32-Bit Microcontroller V850/SV1 Usage Restrictions		Document No.	SBG-T-2477-1-E	1/2
		Date issued	September 11, 2001	
		Issued by	Microcomputer Engineering Dept. Solution Engineering Div. NEC Electron Devices NEC Corporation	
Related documents	User's manual -Hardware: U14462EJ	Notification classification	√	Usage restriction
	User's manual -Architecture: U10243EJ			Upgrade
	Data sheet (Flash memory): U14622EJ			Document modification
	Data sheet (Mask ROM): U13953EJ			Other notification

1. Affected products

2. Details of restrictions

Figure) NOP Insertion Program Flowchart

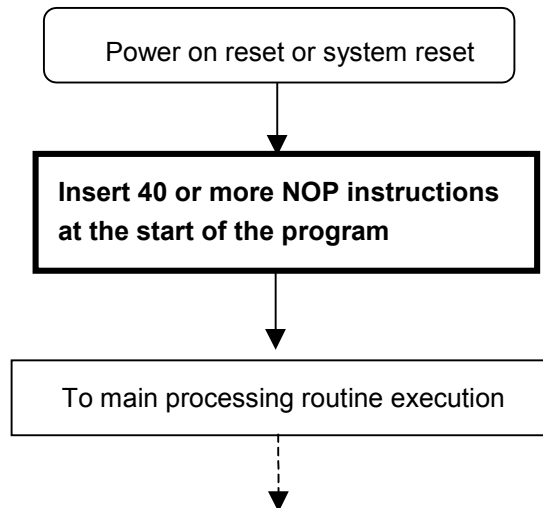
The microcontroller may become inoperable after the power is turned on or the system is reset.

It is necessary to secure time for the voltage to rise sufficiently before the first fetch of the program. To do this, please insert **40 or more** NOP instructions at the start of the program.

(1) When using NMI

If an NMI is used (handler address: 00000010H), it is recommended to change it to external input maskable interrupt INTPO (handler address: 00000090H), etc.

(2) When using NMI

If non-maskable interrupt INTWDT (handler address: 00000020H) of the watchdog timer is used, it is recommended to change it to maskable interrupt INTWDTM (handler address: 00000080H) of the watchdog timer.

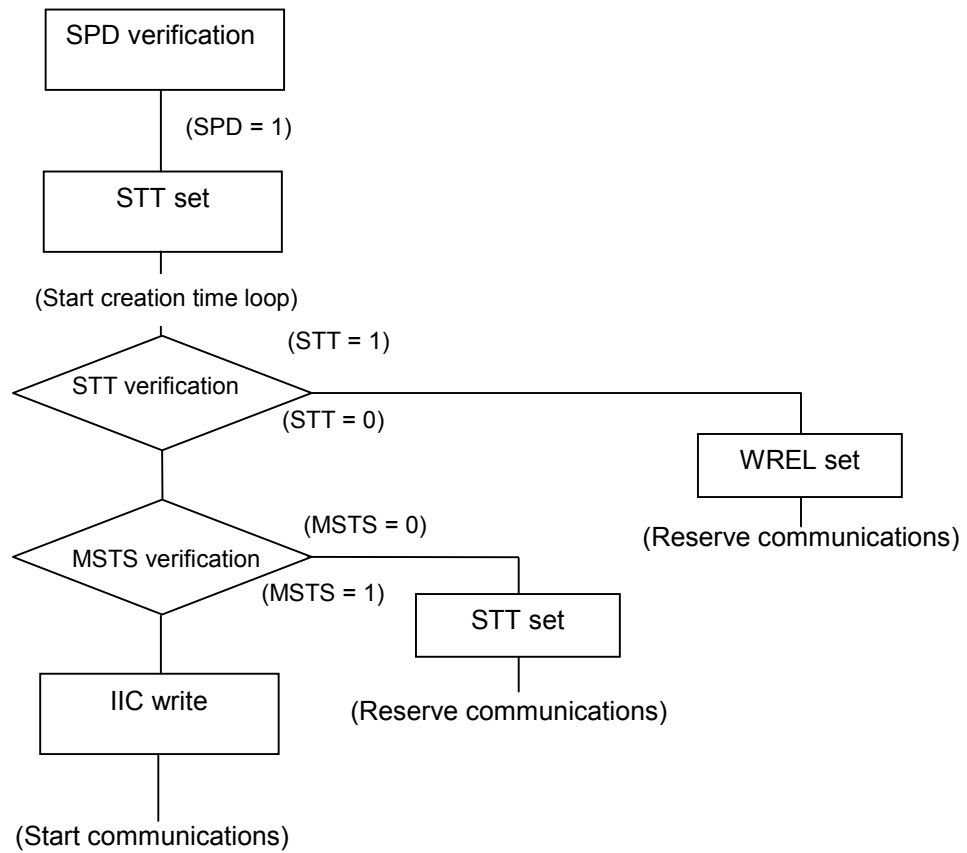
The following bugs may occur as a result of conflict between STT set timing and start condition detection.

- STT bit set operation may be rejected.
- The device may be incorrectly recognized as the master (MAST = 1) and the STT bit cleared.
- A WAIT condition may result from a fall in SCL if STT is set and SCL is in a high-level state (SPD = 1) when the target device has generated a start condition.

STT set timing (during multi-master operation)

Provide software that performs the operations in the flow chart below.

Ensure that the time from SPD verification to WREL set in the above flow chart is as follows.

In high-speed mode: 17.5 μ s or less

In standard mode: 70.0 μ s or less

Figure 2. Interrupt Processing Causing This Bug

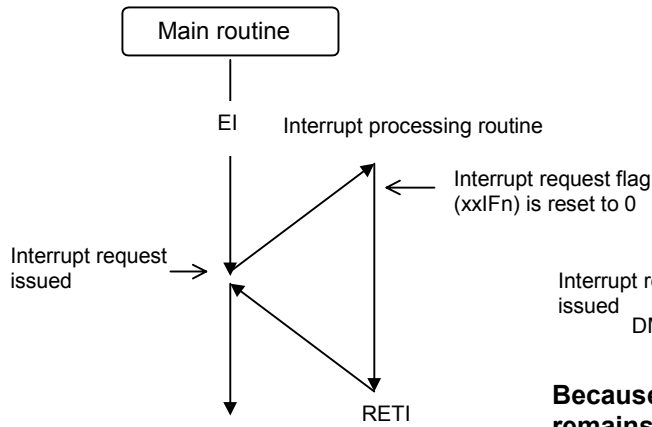
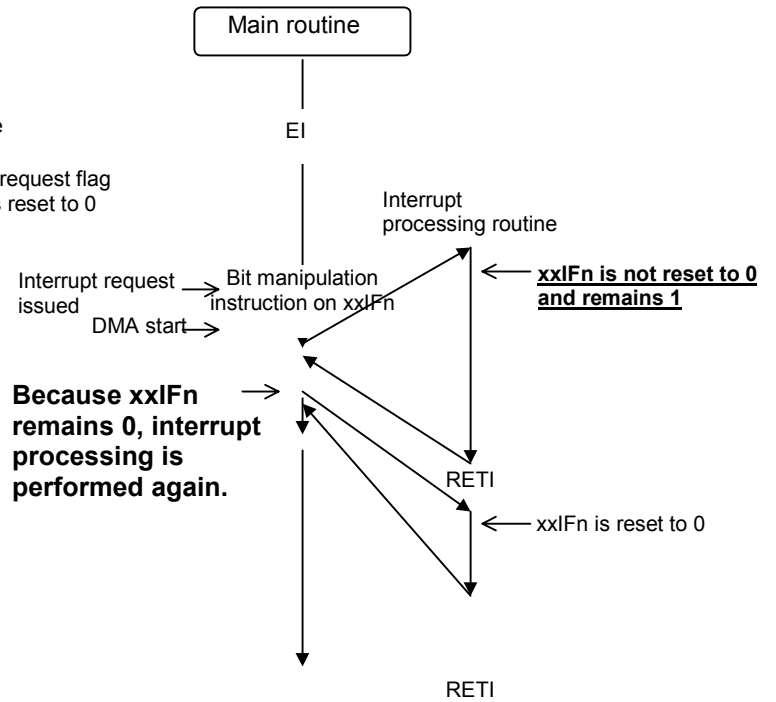
If the three conditions below occur at the same time while interrupts are enabled (EI), an interrupt that should only occur once occurs twice.

- (1) A bit manipulation instruction (set1, clr1, not1, tst1) is executed on an interrupt request flag (xxIFn) of an interrupt control register (xxICn).
- (2) Interrupt processing occurs involving the hardware of the same register as in (1).
- (3) DMA is started while executing the above bit operation instruction.

When the above conditions (1) to (3) coincide and interrupt processing begins, the interrupt request flag that should be reset by hardware is not reset, so that after returning from the interrupt processing routine (RETI instruction), the interrupt processing is executed again. (See figures 1 and 2.)
